Detailed Site Plan

DSP-95073-06

Kaiser Permanente Largo Medical Center

STAFF REPORT

Figure 3: Advanced Urgent Care Addition Elevation

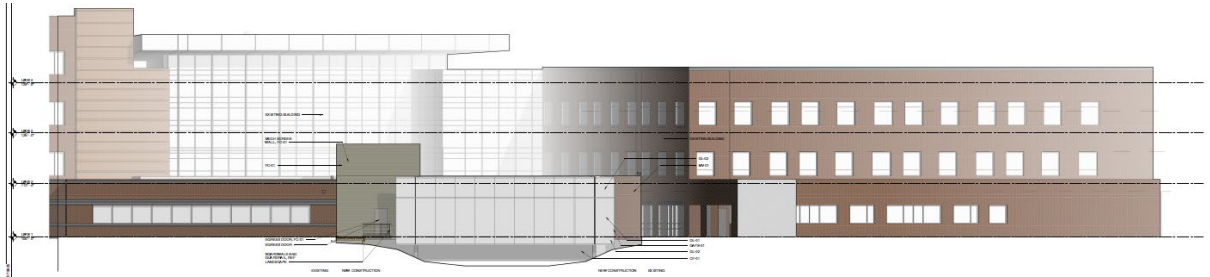
The proposed one-story building additions range in height and are approximately 14 to 18 feet in height. The Advanced Urgent Care addition is located on the west side of the building near the main entrance and the imaging addition is located at the rear of the building on the east side of the structure. The building additions are designed to blend seamlessly with the existing building with proposed materials, including a mix of brick, glass, concrete, fiber cement siding, and metal siding. Trim, coping, and other detail elements such as horizontal banding have been proposed to add architectural interest. The parking garage expansion is located on the west side of the existing parking garage. It is approximately 51 feet in height, 4 stories, and is constructed in brick to match the existing parking garage. The proposed western façade of the garage includes a decorative metal wall panel on the

Figure 5: Proposed Signage

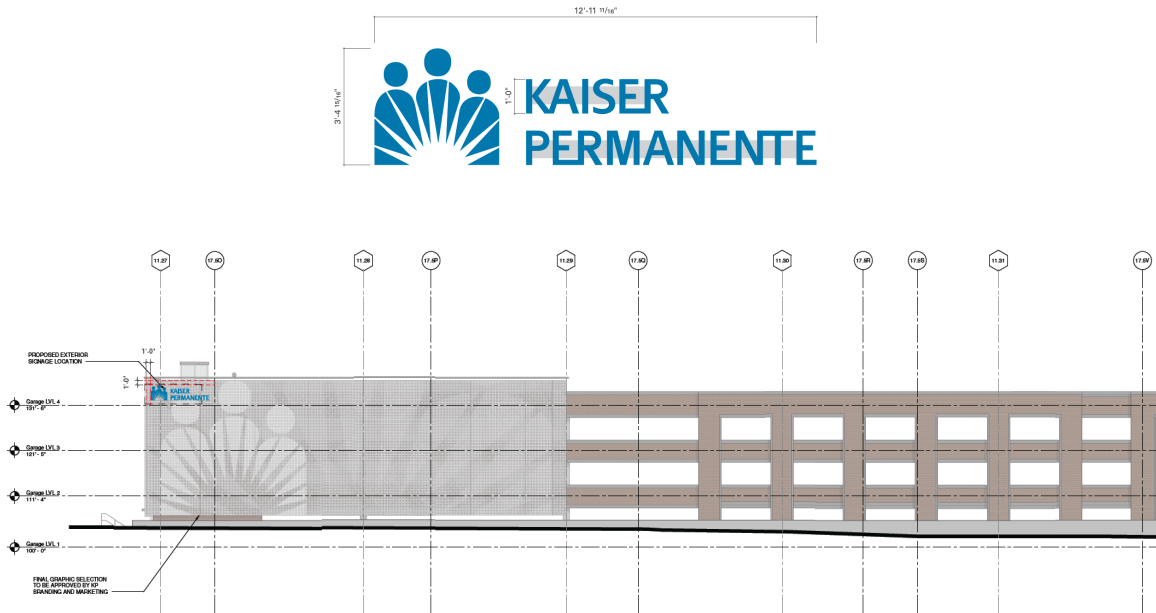
The application proposes one building-mounted sign on the parking garage that is not illuminated and includes the corporate logo and the name of the facility. The proposed sign is located on the west elevation of the parking garage and faces Mercantile Lane and exceeds the allowed square footage. An amendment has been filed by the applicant and staff recommends approval of this request, as discussed in Finding 7.

Figure 5: Proposed Signage

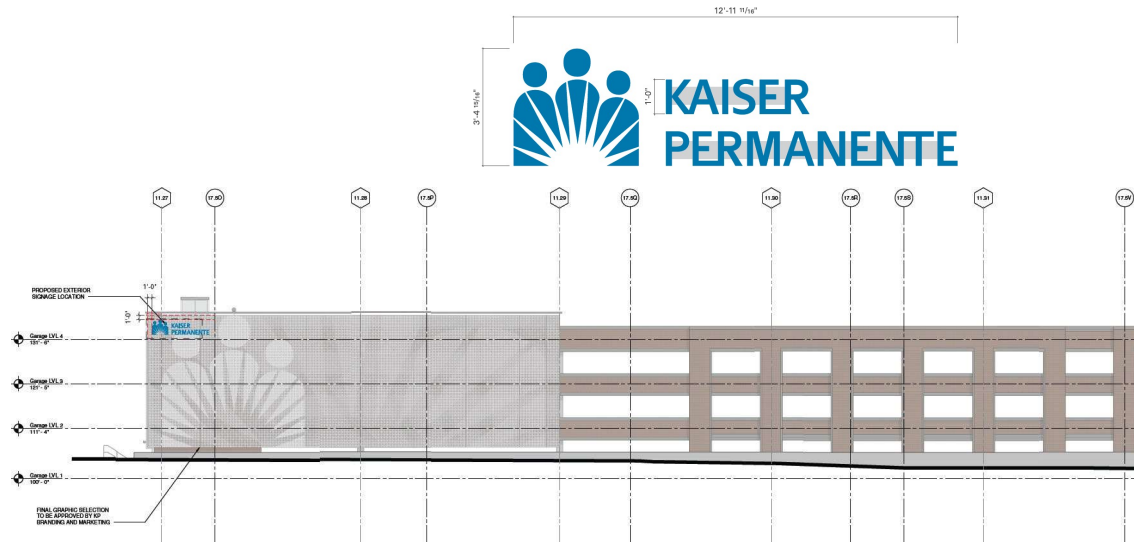
The application proposes one building-mounted **replacement identity** sign on the parking garage that is ~~not~~ illuminated and includes the corporate logo and the name of the facility, **and one perforated graphic panel which incorporates portions of the Kaiser Permanente logo.** ~~Both~~ *The* proposed signs **are** ~~is~~ located on the west elevation of the parking garage **facing** ~~and faces~~ Mercantile Lane and **- in combination -** ~~exceeds~~ the allowed square footage. An amendment has been filed by the applicant and staff recommends approval of this request, as discussed in Finding 7.
